November 7, 2024

ADDENDUM NO. 01 to the plans and specifications for MACOMB COUNTY – COUNTY WAREHOUSE – F & O AND PURCHASING OFFICE RENOVATION, CLINTON TOWNSHIP, MI, Architect’s Project No. 242053, dated OCTOBER 31, 2024

ROOFTOP SCREEN DETAIL
NO SCALE

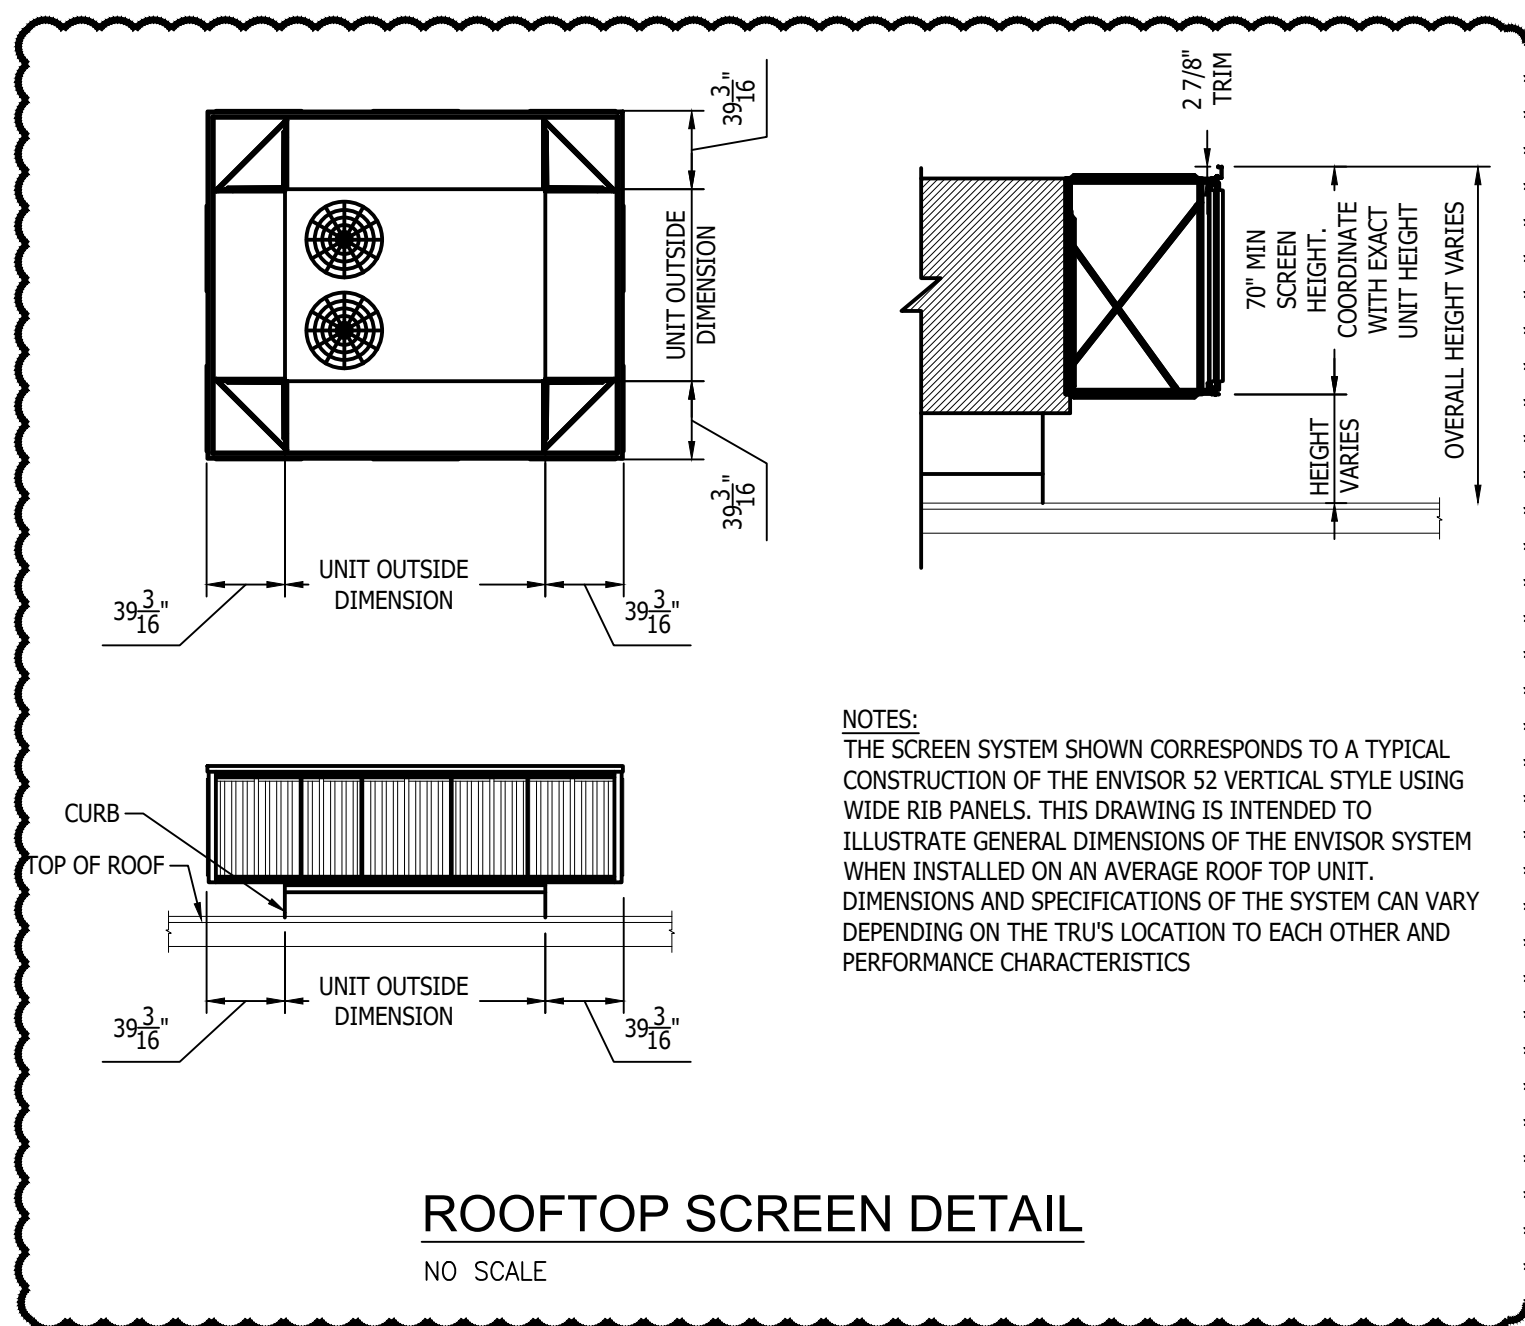
2. Added rooftop unit screening detail
 3. Added rooftop unit cooling drain pan detail
 4. Added gas piping connection detail
- ITEM NO. M10:** Refer to sheet M6.00 – Mechanical Schedules (Re-issued);

ELECTRICAL POWER NEW WORK FIRST FLOOR PLAN
SCALE: 1/8" = 1'-0"

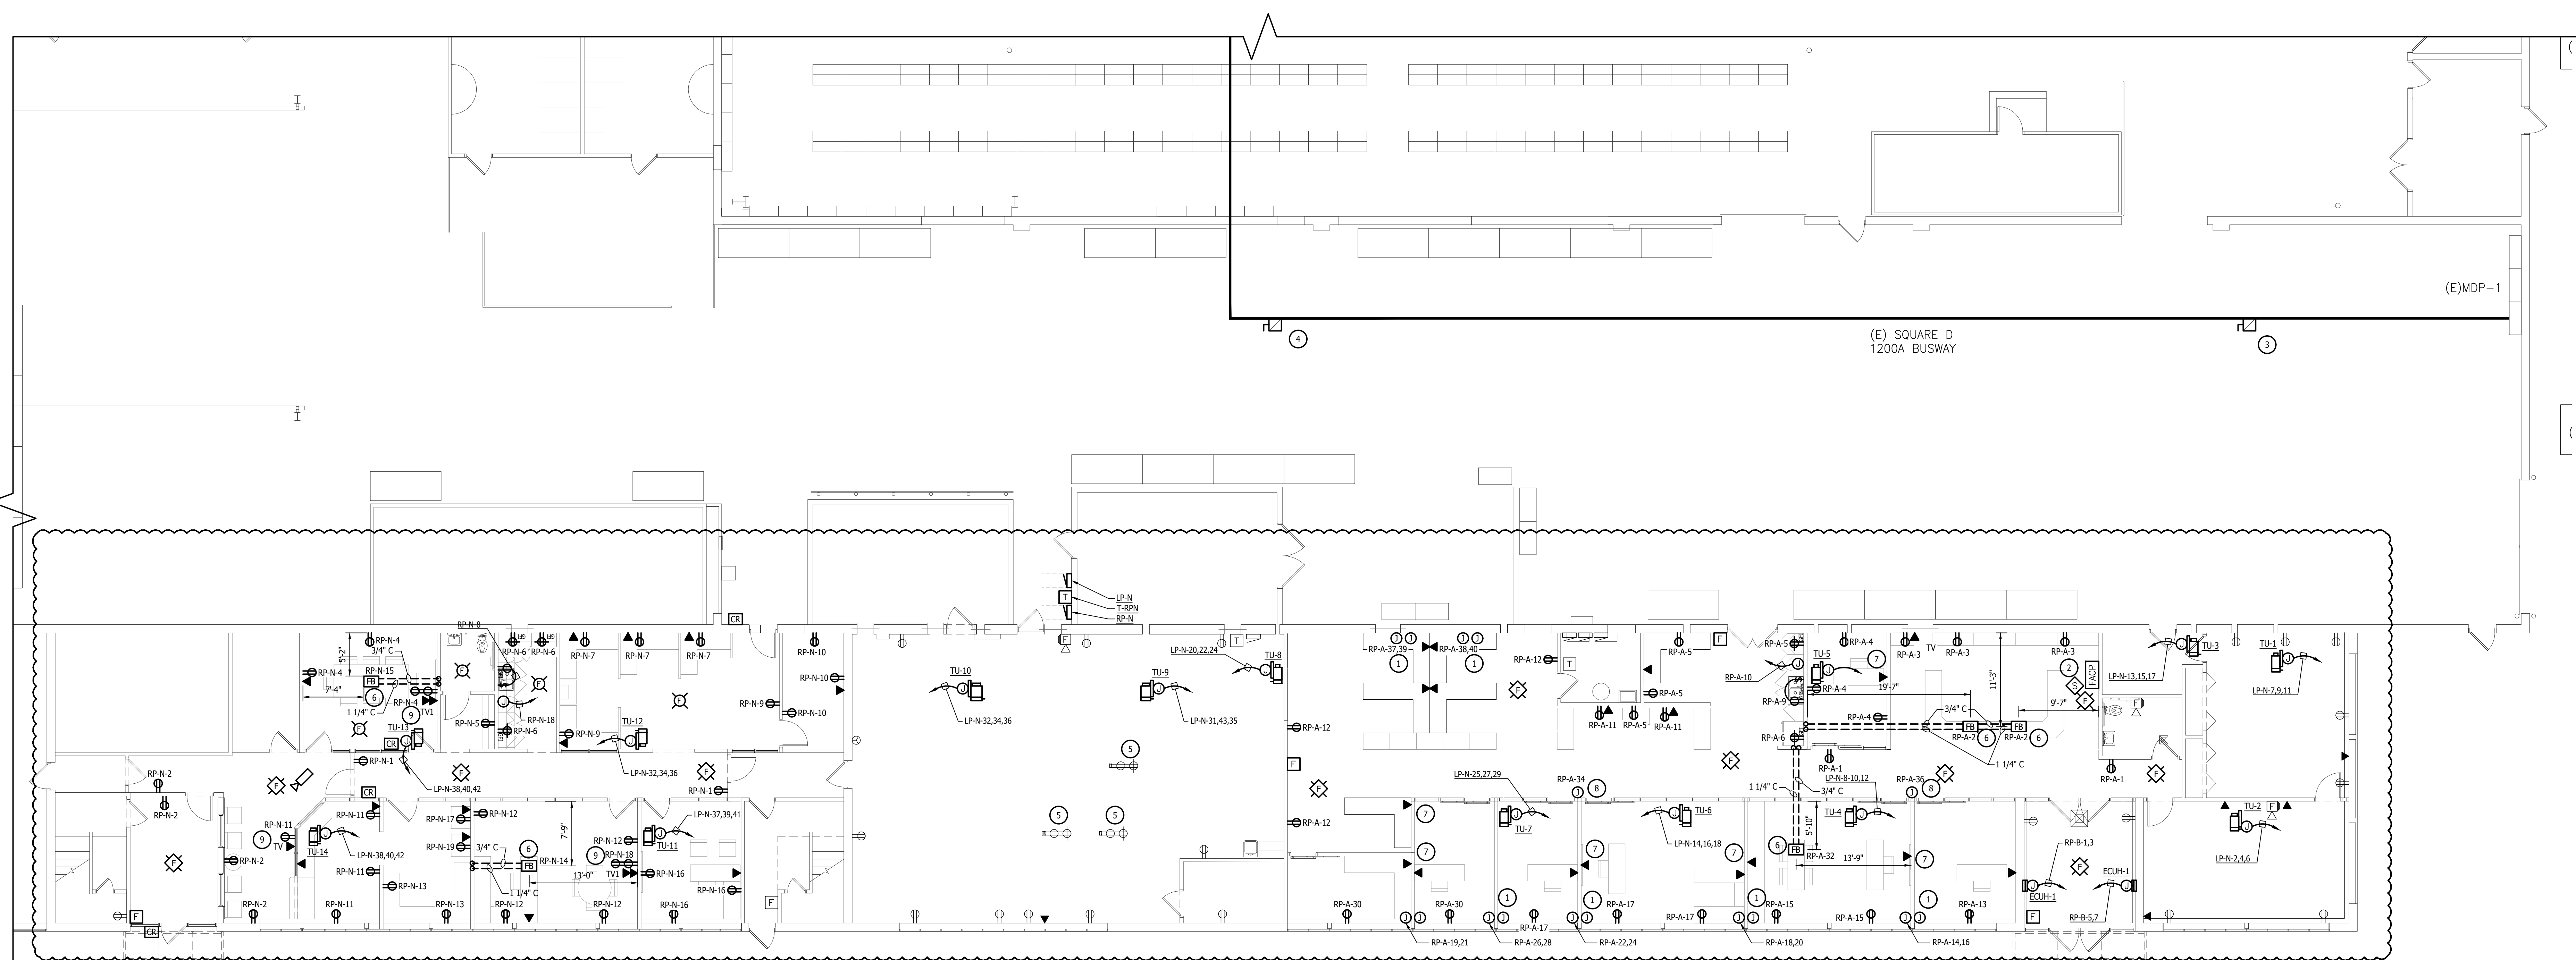
- ITEM NO. E6:** Refer to sheet EP1.10 Electrical Power New Work First Floor Plan (Re-issued);
1. Adjusted Project number on plans as indicated.
 2. Added circuit numbers as indicated on plans.

3. Added data outlets as indicated on plans.
 4. Added 3 TV locations as indicated on plans.
 5. Added Keynotes 6,7,8, and 9.
 6. Added power for ECUH.
- ITEM NO. E7:** Refer to sheet EL1.10 Electrical Lighting New Work First Floor Plan (Re-issued);

ELECTRICAL LIGHTING NEW WORK FIRST FLOOR PLAN
SCALE: 1/8" = 1'-0"

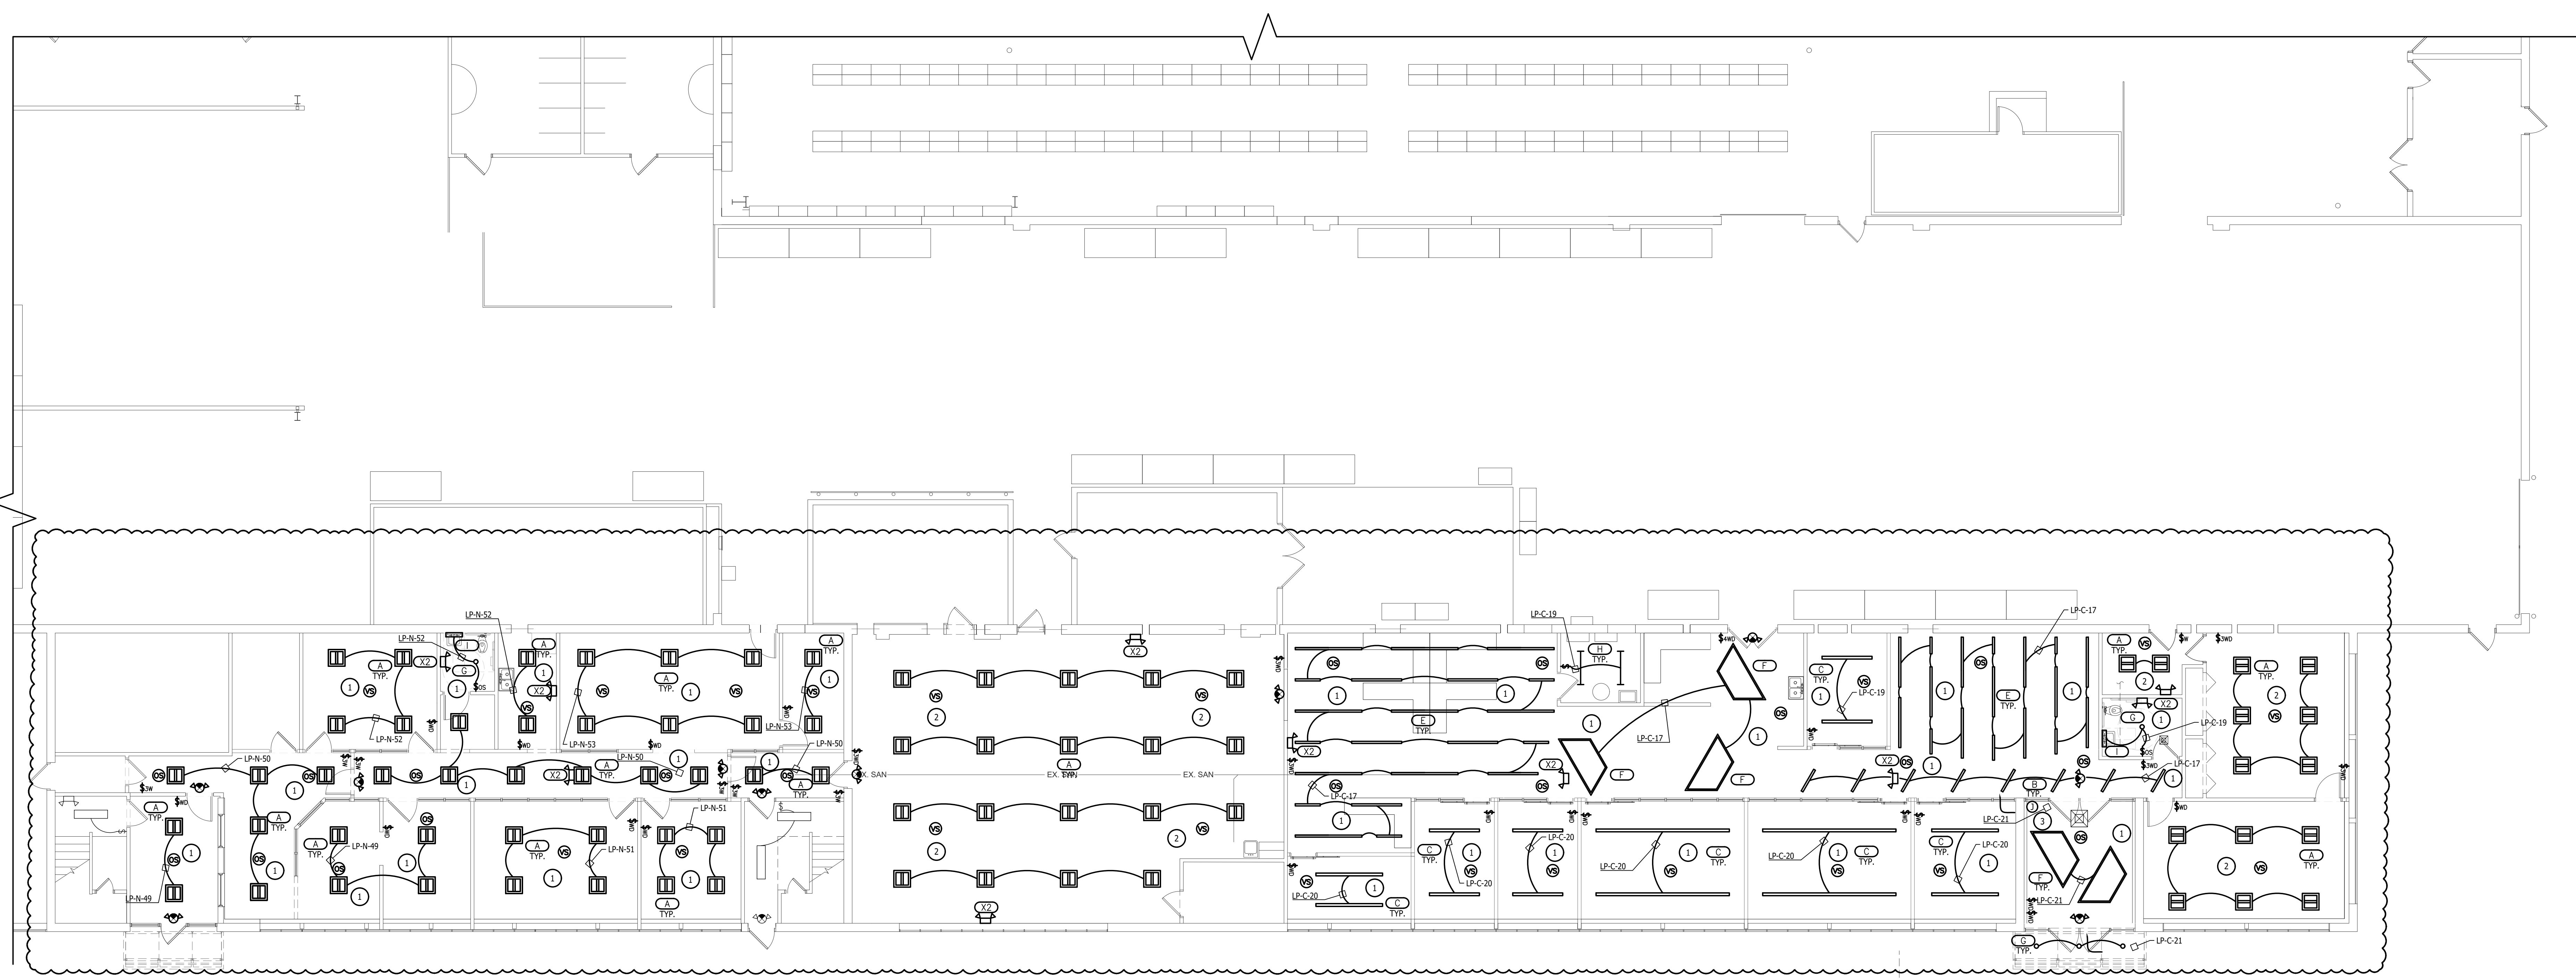
1. Adjusted Project number on plans as indicated.
 2. Added circuit numbers as indicated on plans.
 3. Adjusted lighting in vestibule/main entrance as indicated on plans.

4. Adjusted lighting in open office as indicated on plans.
- ITEM NO. E8:** Refer to sheet E2.10 Electrical Power New Work Roof Plan (Re-issued);
1. Adjusted Project number on plans as indicated.

2 GANG FLOOR BOX DETAIL
SCALE 1/8"=1'-0"

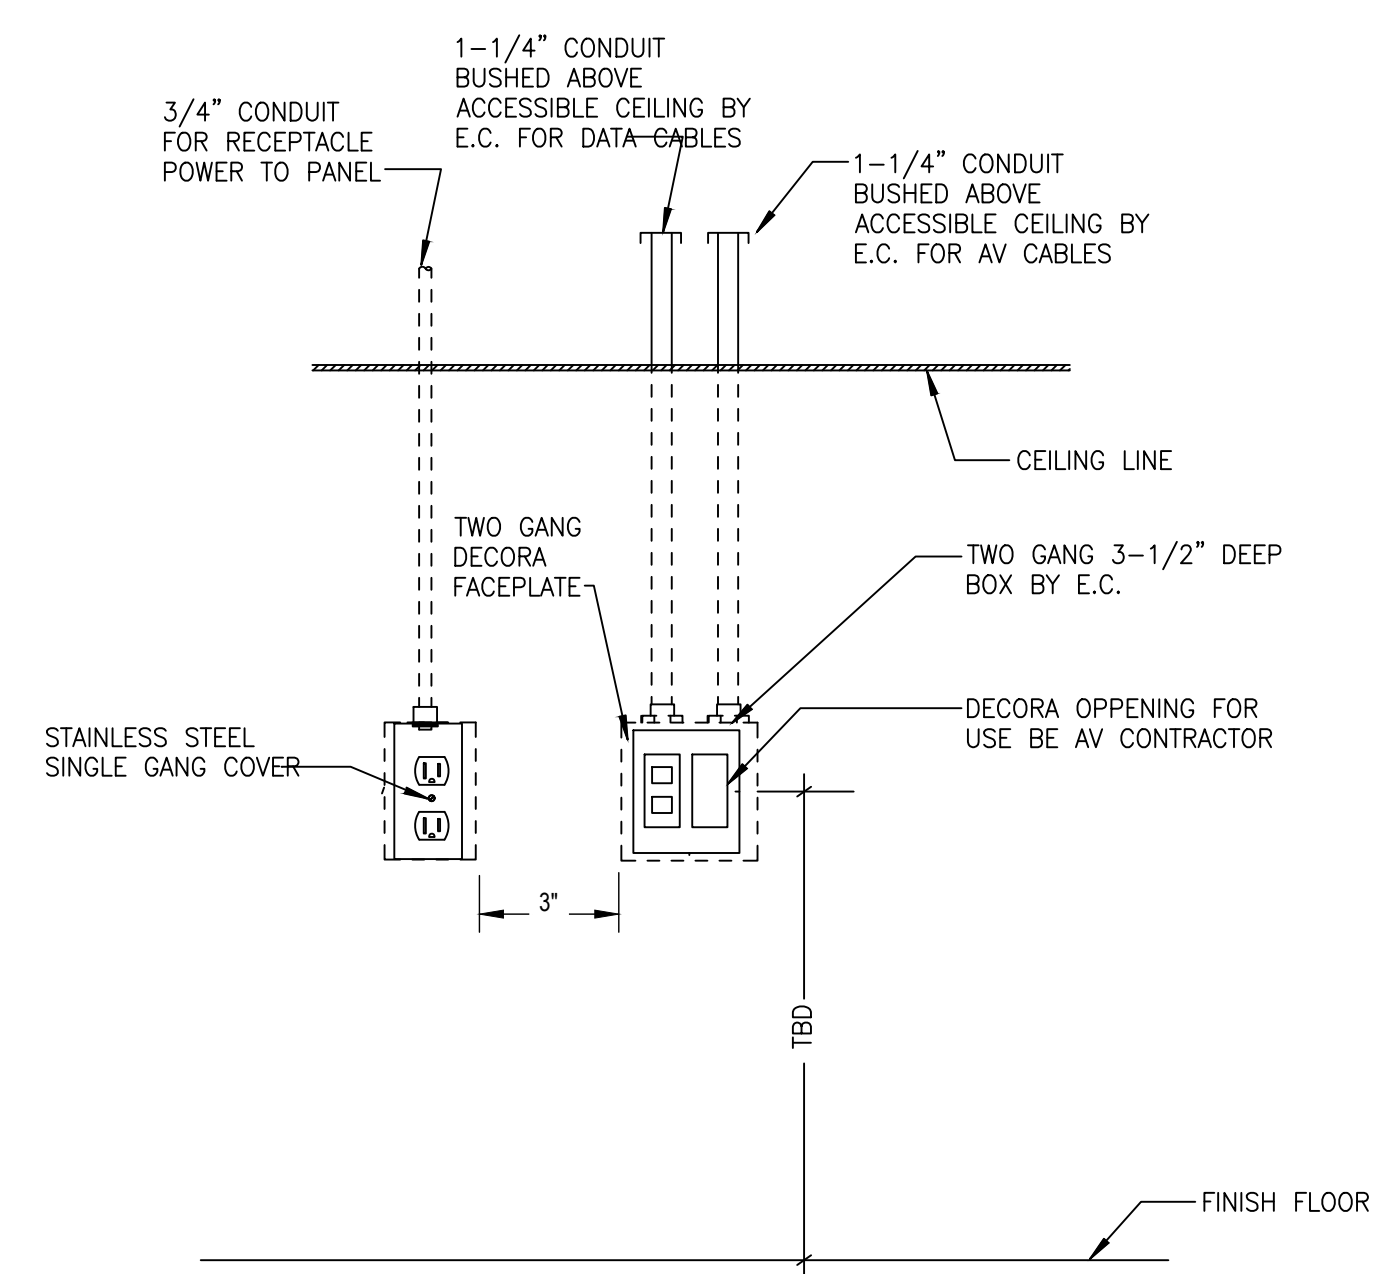
- ITEM NO. E9:** Refer to sheet E5.00 Electrical Details (Re-issued);
1. Adjusted Project number on plans as indicated.
 2. Added 2 Gang Floor Box Detail.

TYPICAL TV POWER AND LOW VOLTAGE DETAIL
NO SCALE

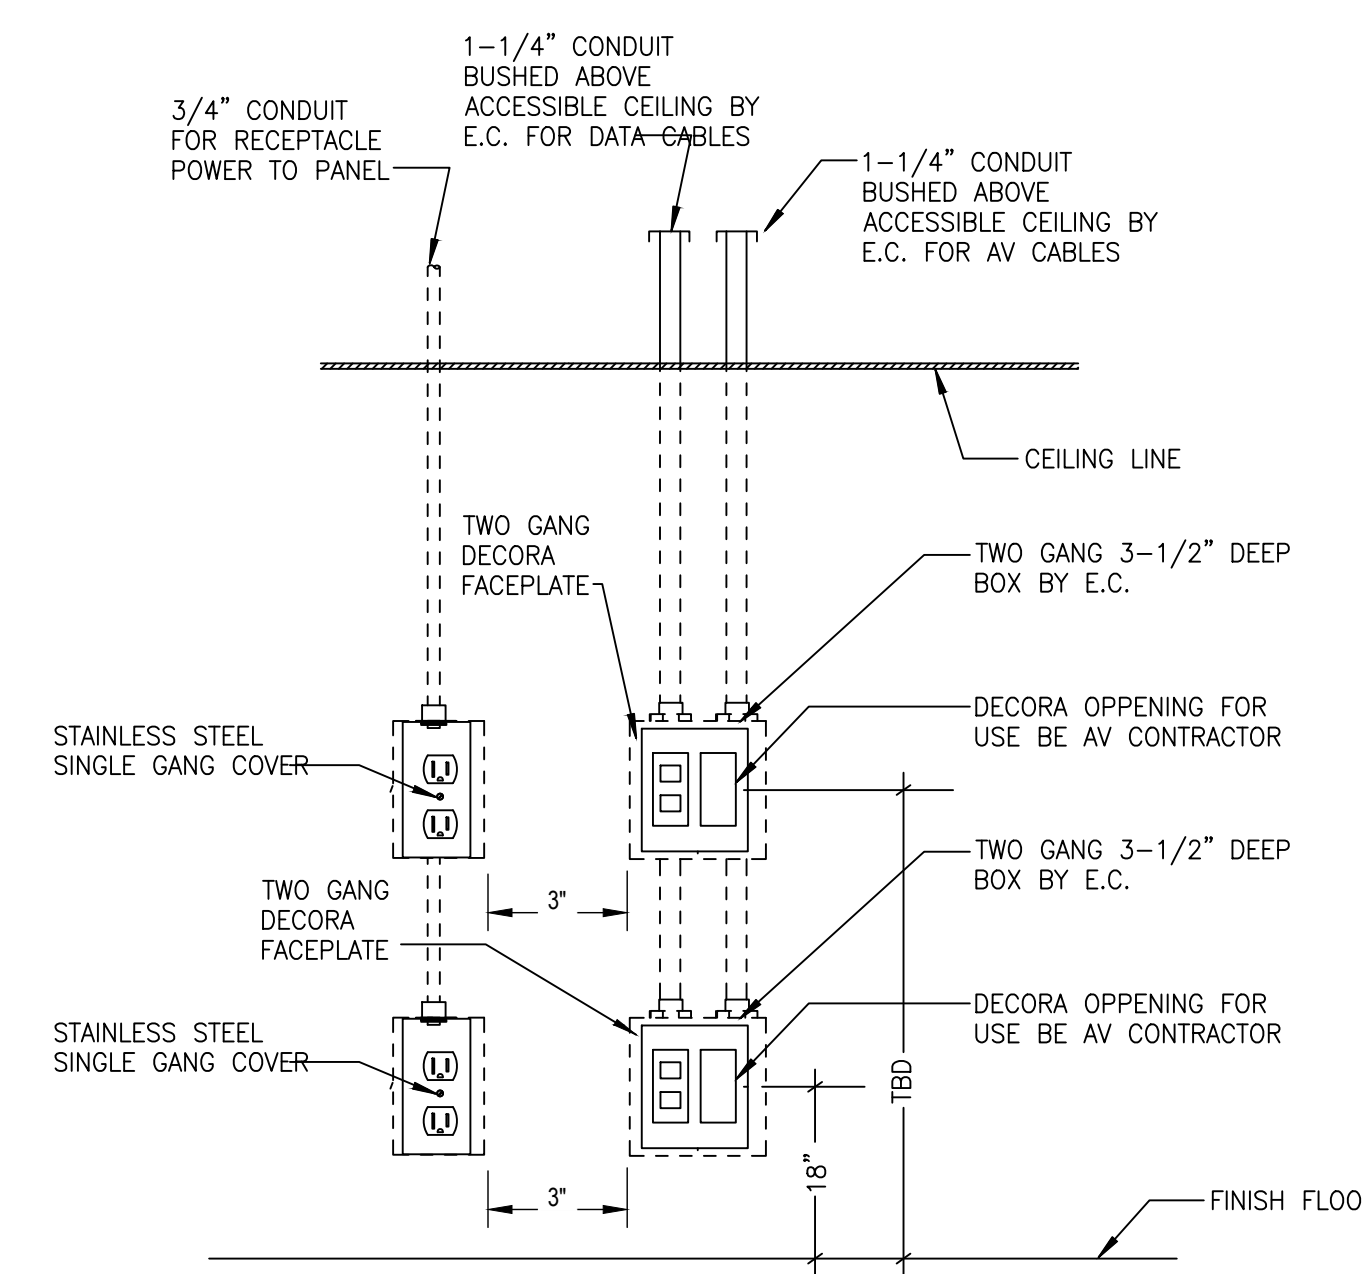
3. Added TV Detail.
 4. Added TV1 Detail.
 5. Added Card Reader Detail.
 6. Added TELE/AV/AV Outlet Detail.
- ITEM NO. E10:** Refer to sheet E6.00 Electrical Panel Schedules (Re-issued);
